DATE ~~R~~ Mar.12/03**V2500-D5 NACELLE SERVICE BULLETIN**

This document transmits Revision 1 to Service Bulletin NV2500-78-0170 and
 Revision 1 to the Supplement

Reason for change
 To revise kit contents and
 make related changes to
 text and illustration.

NACELLE - EXHAUST - TRANSLATING SLEEVE AFT LATCH, HEAT SHIELD MODIFICATION/LATCH
ACCESS DOOR HINGE MODIFICATION, THRUST REVERSER

Lower Translating Sleeve Latch Heat Shield Installation
Figure 2 (Sheet 1)

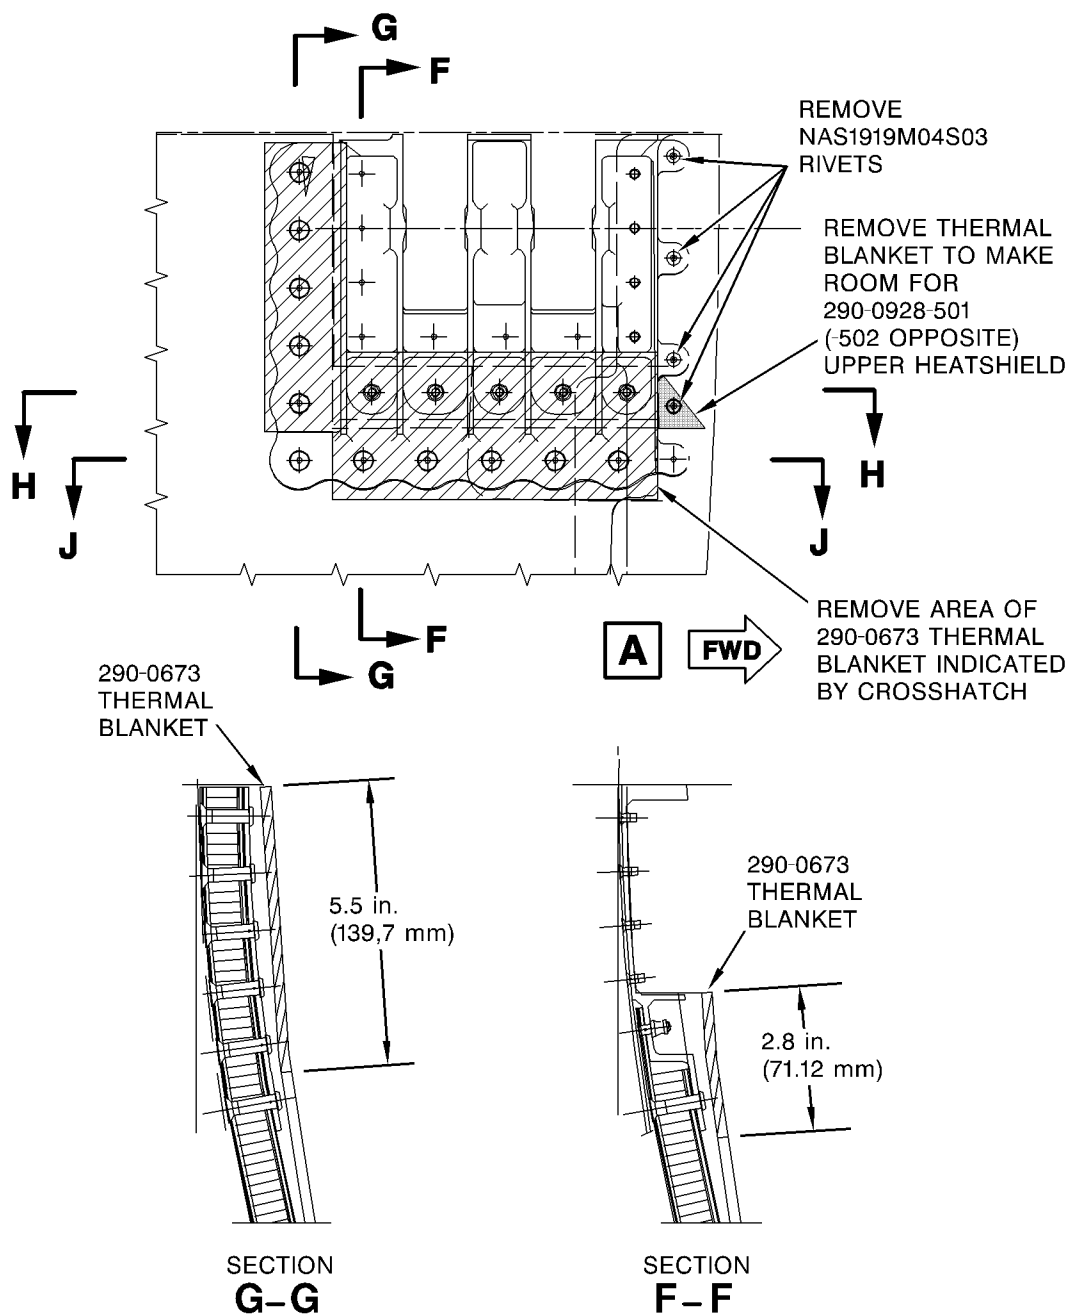
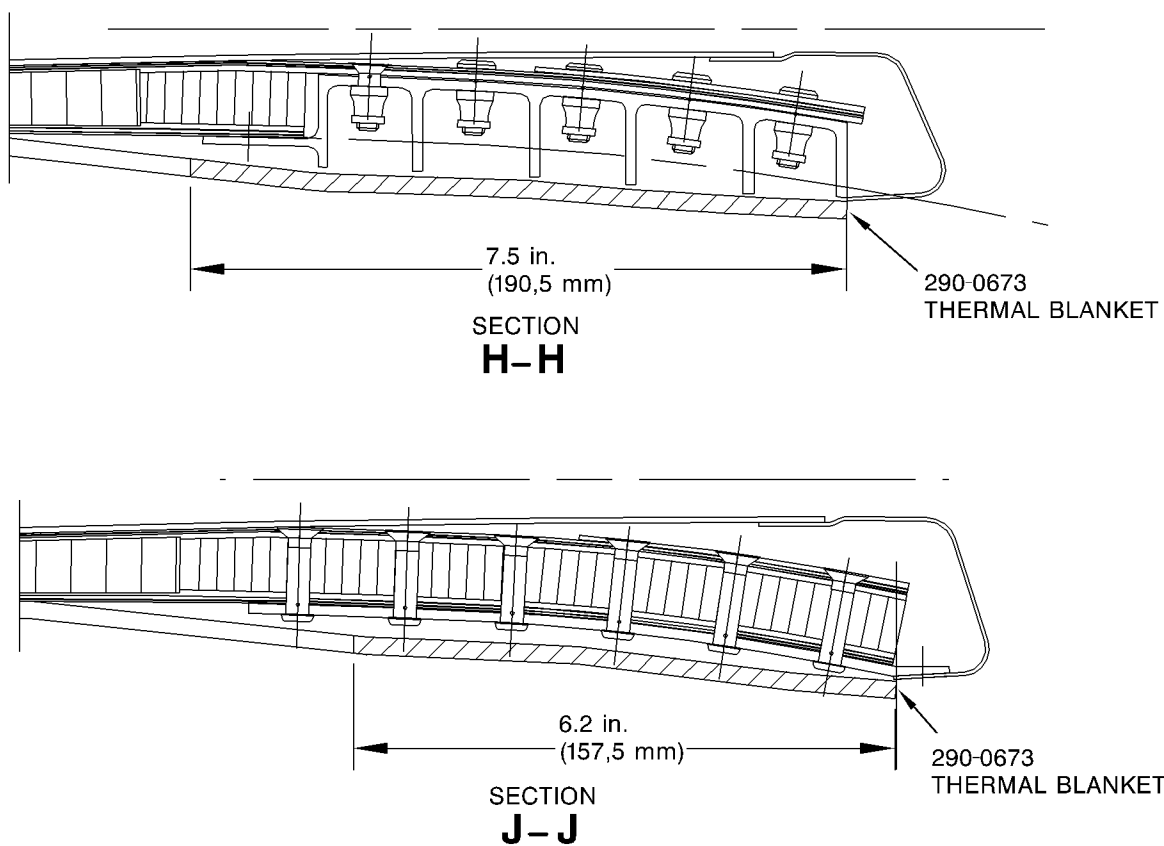
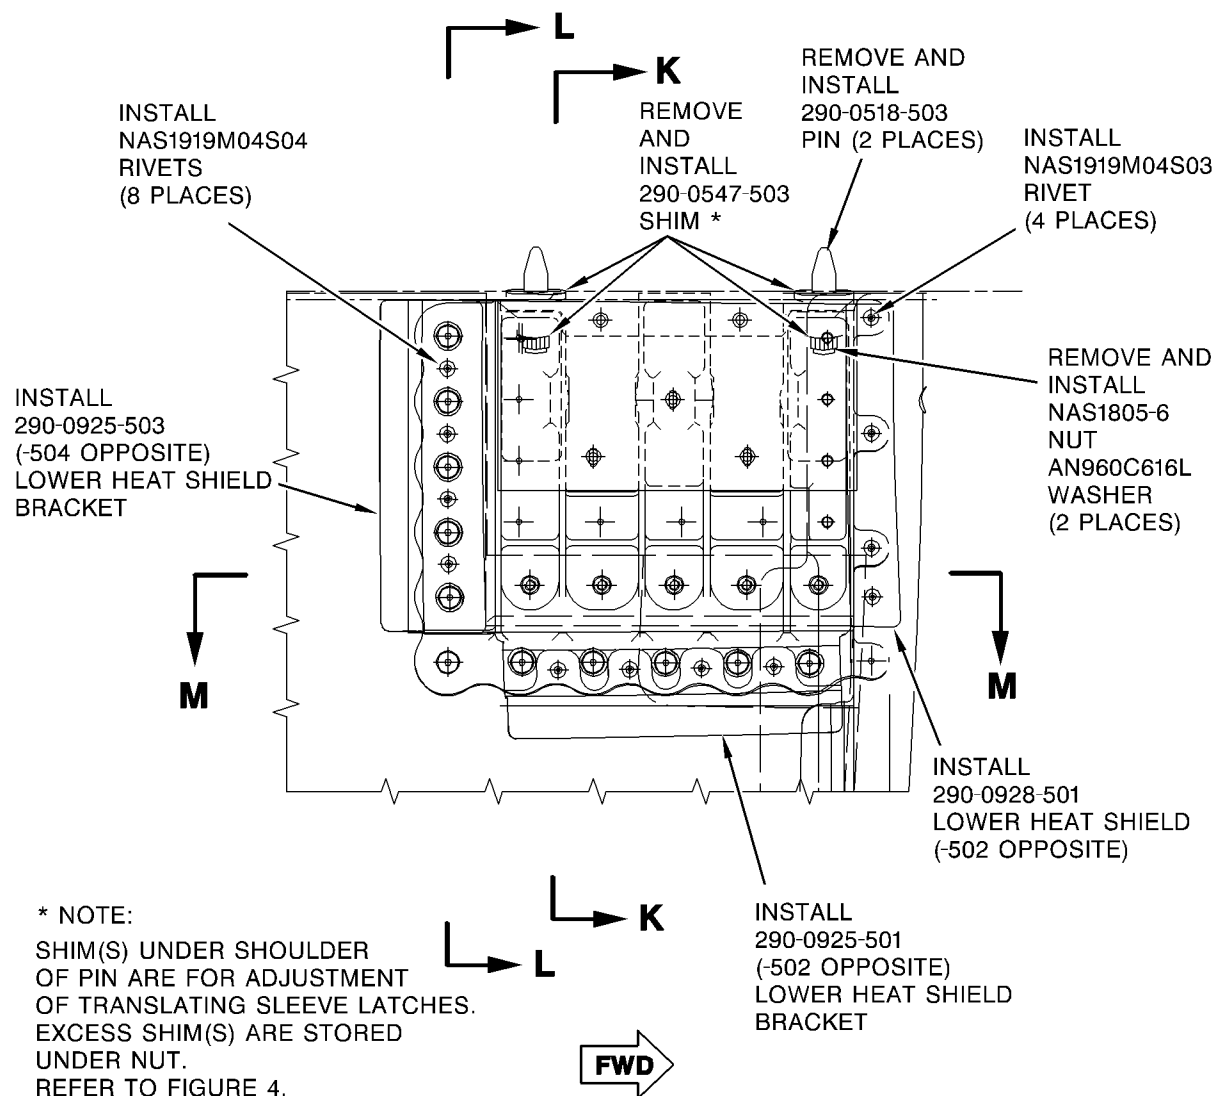
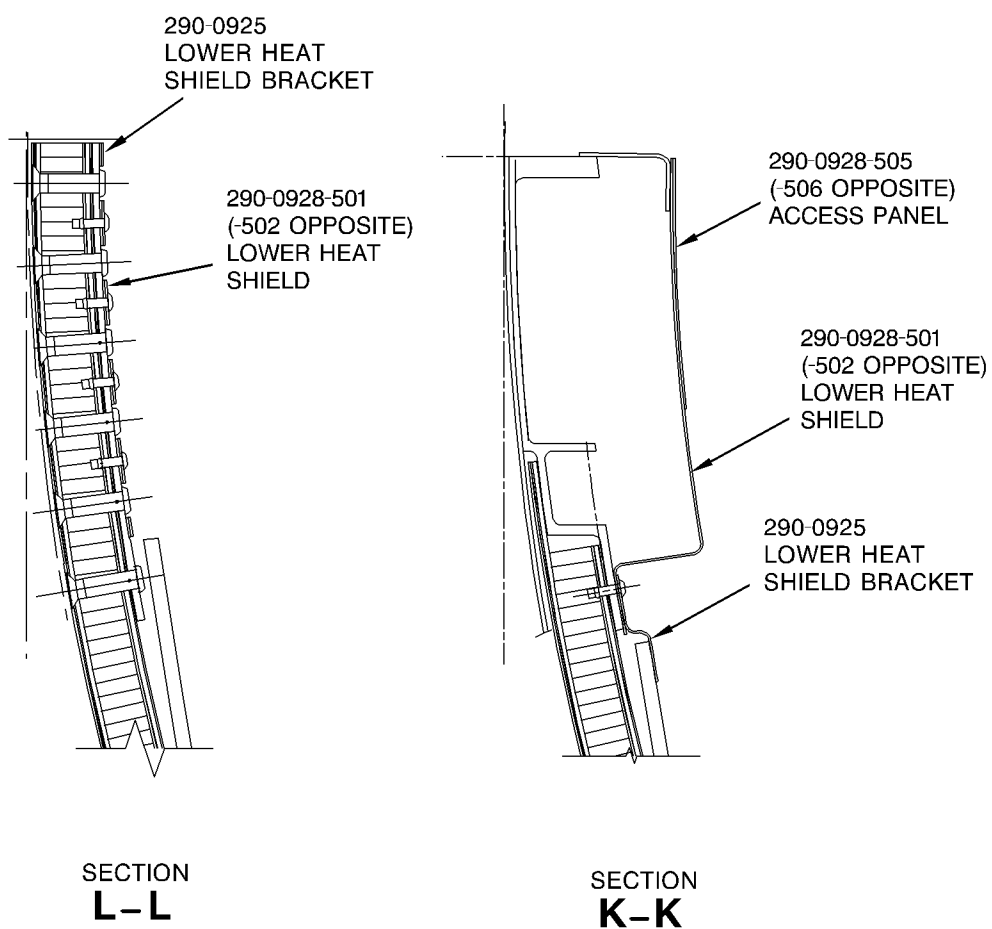
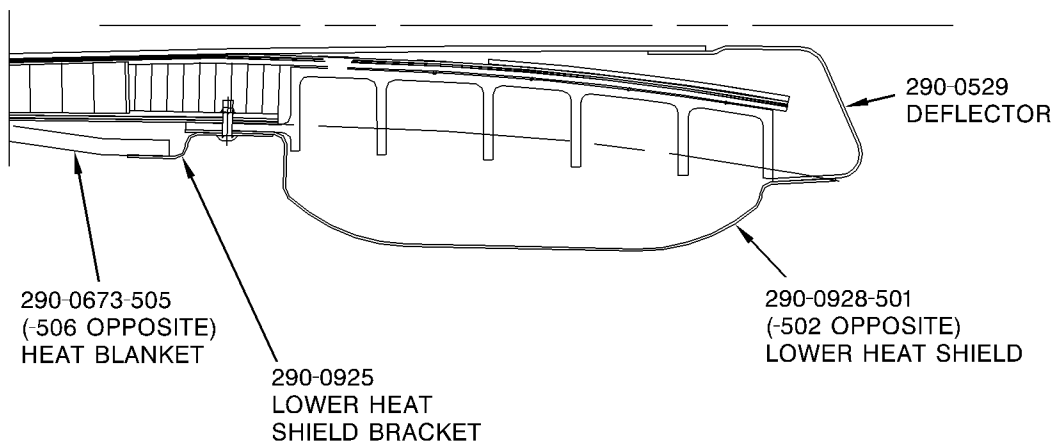
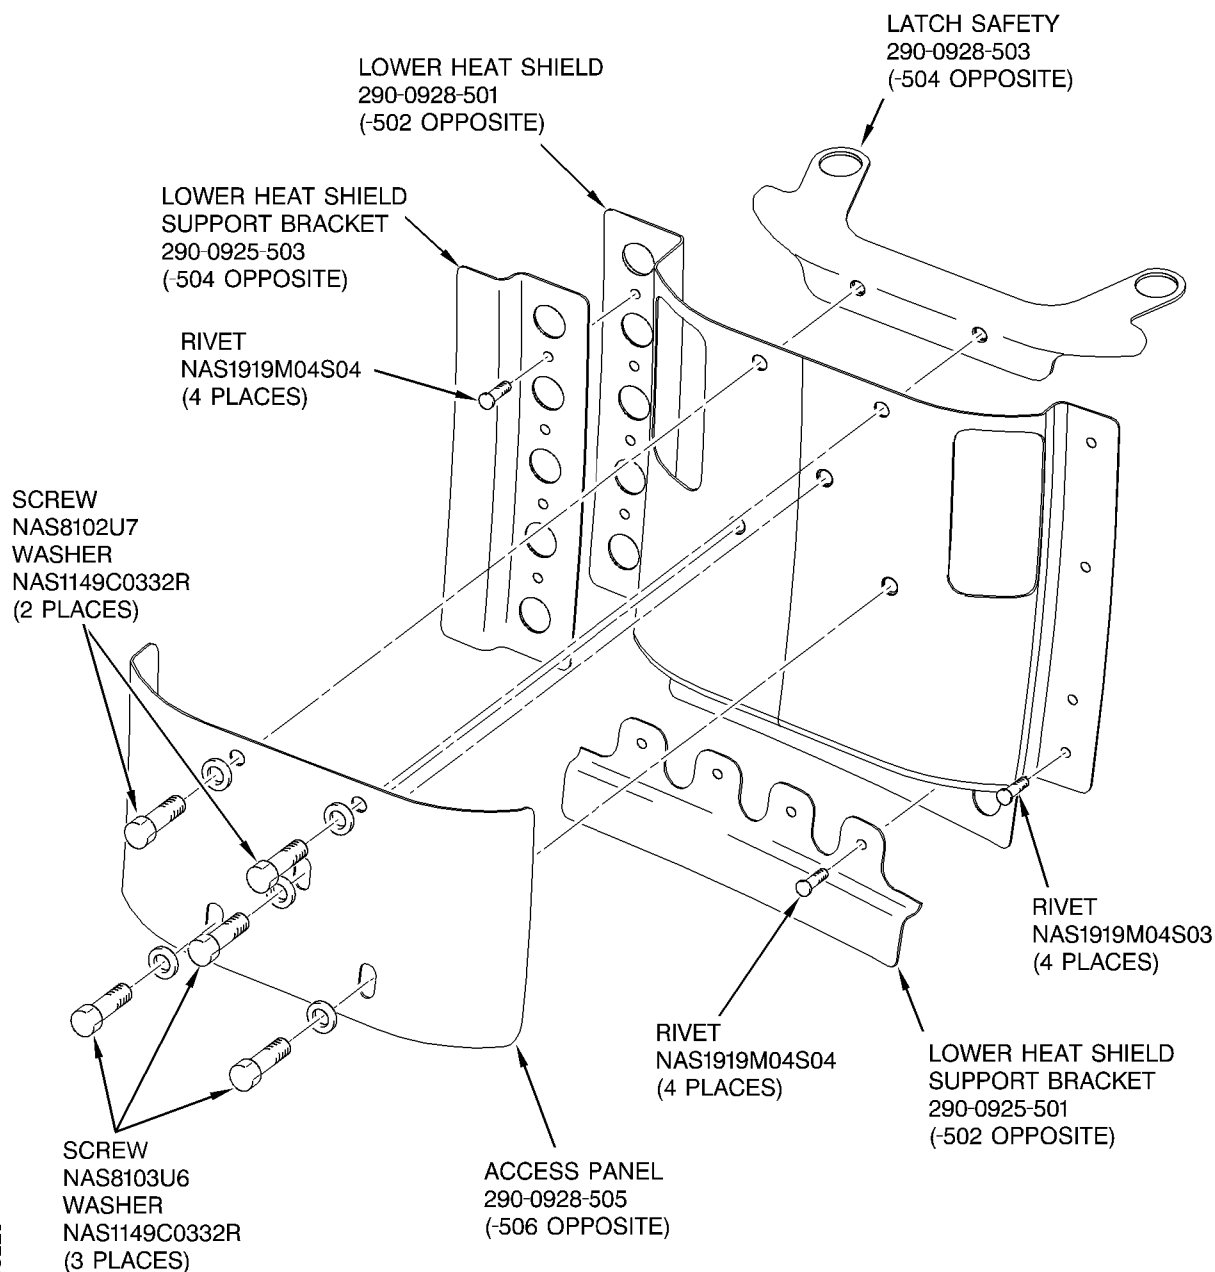
B. Modify the Lower Translating Sleeve Heat Shield. Refer to Figure 2.

- (1) Extend the translating sleeves to the deployed position. Refer to the MD-90 Aircraft Maintenance Manual, Chapter 78-32-00, Page Block 201.
- (2) Remove the nuts, washers, locating pins, shims and latch safety from the latch housing. Keep the washers. Discard the latch safety, the shims, and any damaged nuts or locating pins.
- (3) Remove material from the lower translating sleeve thermal blanket to make room for the new heat shield and support brackets.

- (4) Remove four rivets from the 290-0529 deflector.
- (5) Put the 290-0928-501 (-502) heat shield and the 290-0925-501 (-502) and 290-0925-503 (-504) support brackets into position on the translating sleeve.
- (6) Match drill the four holes from the 290-0529 deflector into the 290-0928-501 (-502) heat shield.
- (7) Match drill the eight pilot holes from the 290-0925-501 (-502) and 290-0925-503 (-504) support brackets through the 290-0928-501 (-502) heat shield, the latch housing, and the inner skin of the bond panel.

- (8) Mix the catalyst (CoMat 07-139), epoxy primer (CoMat 07-140), and thinner (CoMat 07-144). Refer to the manufacturer's instructions.
- (9) Install the 290-0928-501 (-502) heat shield and support brackets 290-0925-501 (-501) and 290-0925-503 (-504) on the translating sleeve with eight NAS1919M04S04 rivets and four NAS1919M04S03 rivets. Wet install the rivets with primer mix.

- (10) Install the 290-0928-503 latch safety, 290-0518-503 locating pins, AN960C616L washers, and NAS1805-6 nuts on the lower translating sleeve latch housing. Do not install the shims at this time. Tighten but do not torque the nuts at this time.

- (13) Apply sealant (CoMat 08-030) to the cut edges of the thermal blanket and the area between the thermal blanket and the support brackets to make a heat barrier.

Track Beam Seal Installation
Figure 3 (Sheet 1)

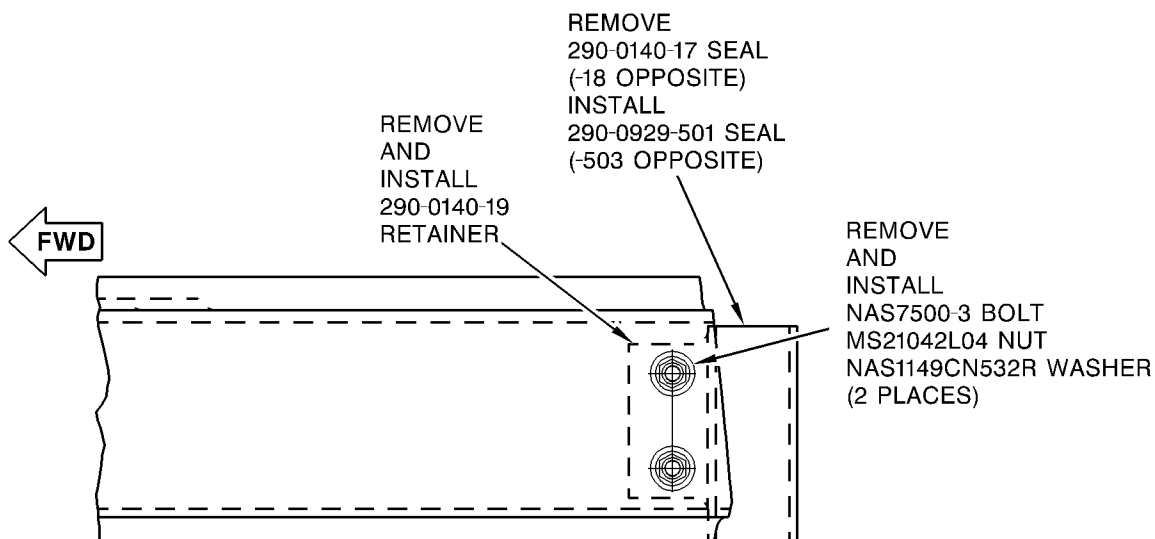
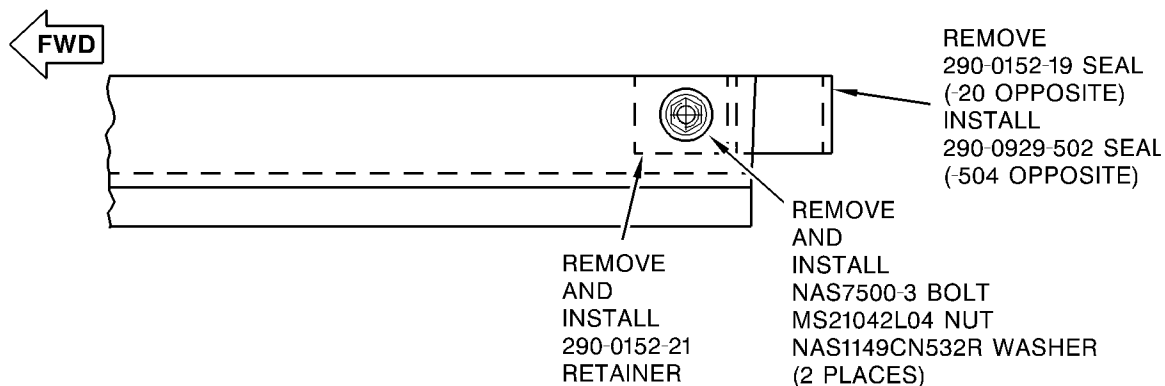
C. Remove and Install the Translating Sleeve Track Beam Seals. Refer to Figure 3.

- (1) Remove the 290-0140-17 (-18) seals from the upper track beam. Discard the seal. Keep the attaching hardware.
- (2) Remove the 290-0152-19 (-20) seals from the lower track beam. Discard the seal. Keep the attaching hardware.
- (3) Install the 290-0929-501 (-502) seal on the upper track beam. Do not tighten the attaching hardware.

- (4) Install the 290-0929-503 (-504) seal on the lower track beam. Do not tighten the attaching hardware.
- (5) Retract the translating sleeves to the stowed position. Refer to the MD-90 Aircraft Maintenance Manual, Chapter 78-32-00, Page Block 201.
- (6) Move the 290-0929-501 (-502) and 290-0929-503 (-504) seals until they are 10% to 30% compressed against the translating sleeve.
- (7) Torque the MS21042L04 nuts to 12 to 16 in-lbs.
